HCA HEALTHONE AURORA

SPD EXPANSION

CITY & STATE - 1ST REVIEW - 2026/09/21

City of Aurora Building Division
Project: *STERILE PROCESSING DEPT EXPANSION*
Address: *1501 S POTOMAC ST*
Occupancy Group: *IBC I-2*
Construction Type: *UBC Type I-F.R. - SPK*
RSN: *2005238*
Permit: *2026 2656467*

1 PHASING DEMO PLAN - LEVEL 1
1/4" = 1'-0"

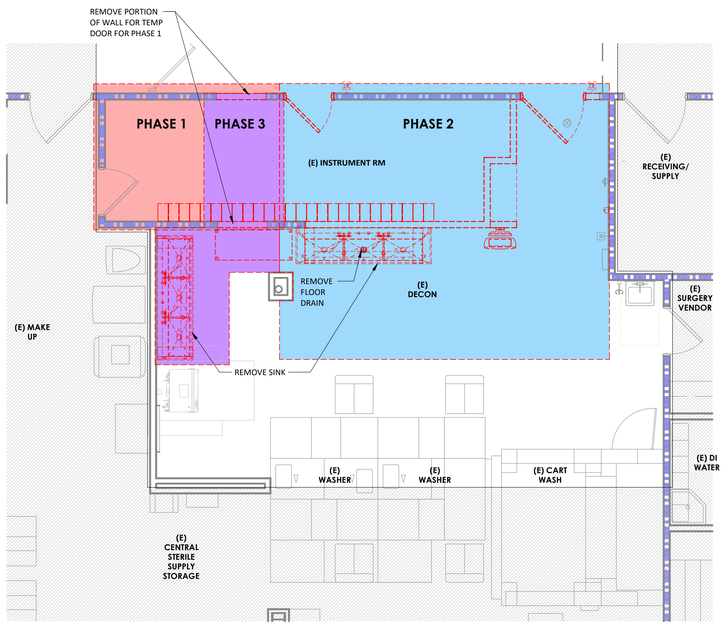
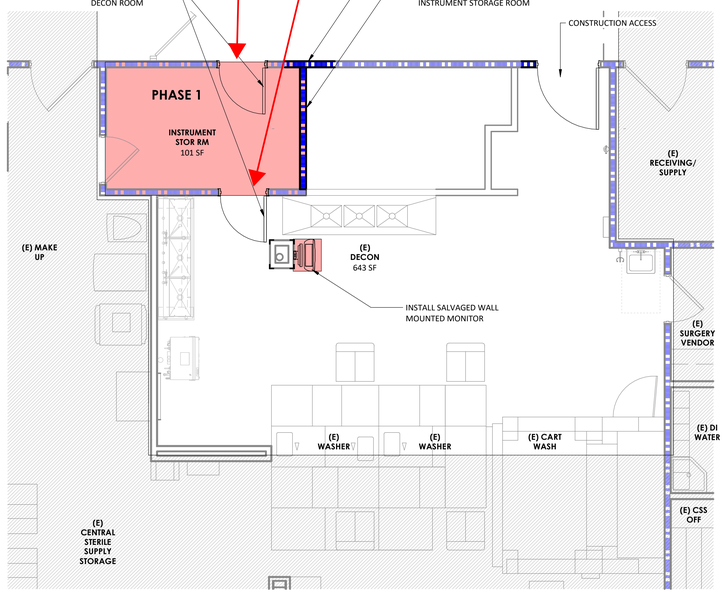
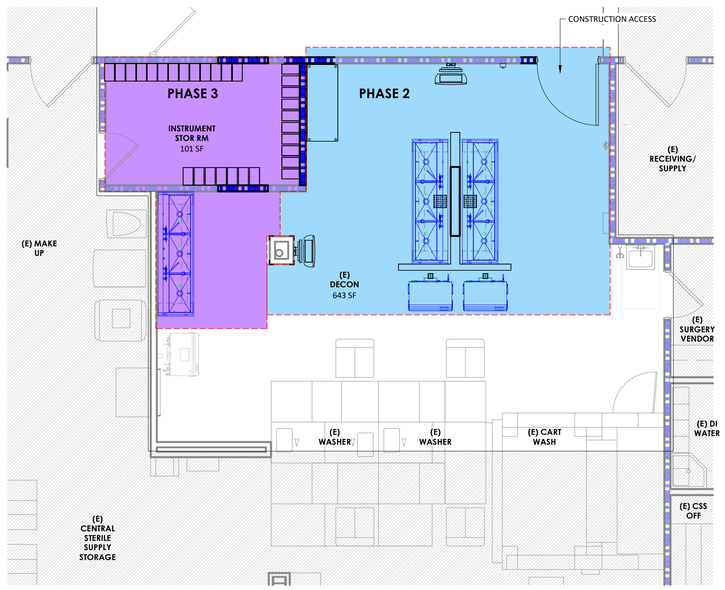
AT ALL TIMES DURING CONSTRUCTION, MAINTAIN REQUIRED EXITS, EXISTING STRUCTURAL ELEMENTS, FIRE PROTECTION AND SANITARY GUARDS PER 2021 IBC 3302.1

Temporary doors must have a minimum fire-resistance rating of 45 minutes, in accordance with 2021 IBC Table 716.1(2)

1 LIFE SAFETY PLAN - LEVEL 1
1/8" = 1'-0"

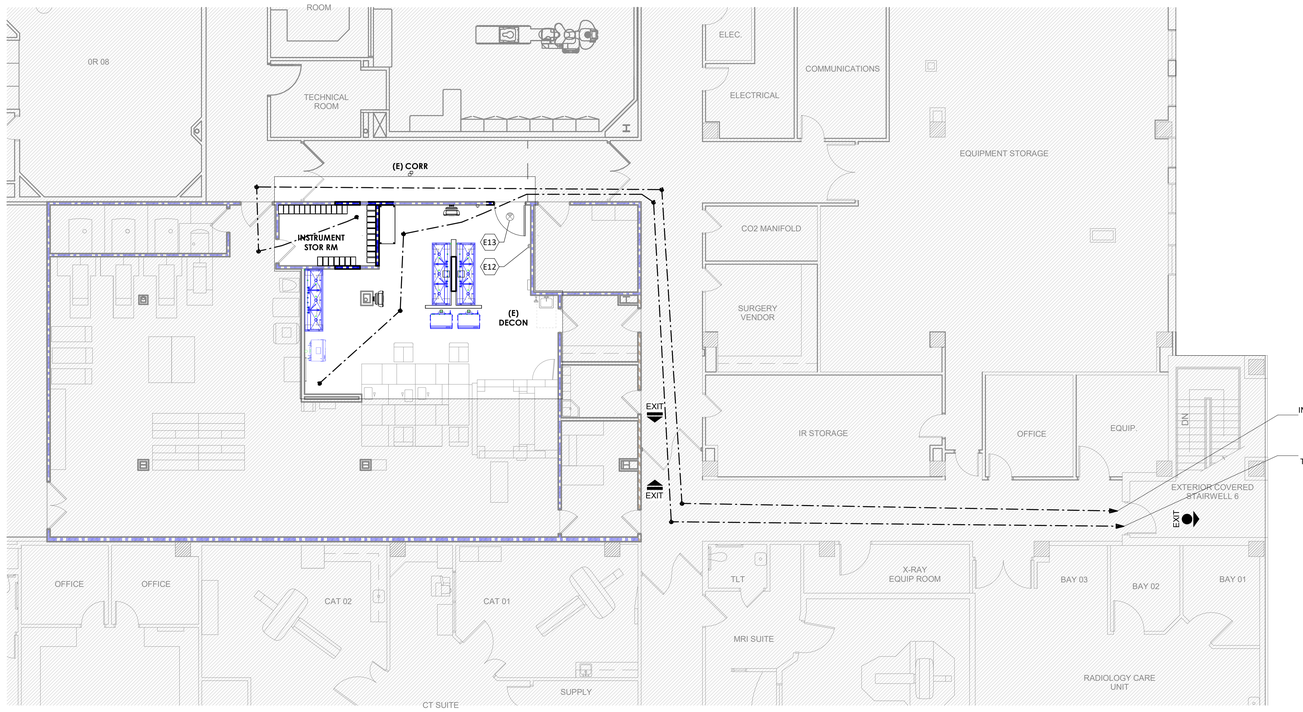
Consultation for exit signs and emergency lights is available upon request. Call 303.739.7420 prior to final Life Safety inspection to verify proposed locations.

Consultation for fire extinguisher placement is available upon request. Call 303-739-7420 prior to final Life Safety inspection to verify proposed locations.

Exits and exit access doors shall be marked by an approved exit sign readily visible from any direction of egress travel. Exit sign placement shall meet 2021 IBC 1013.1
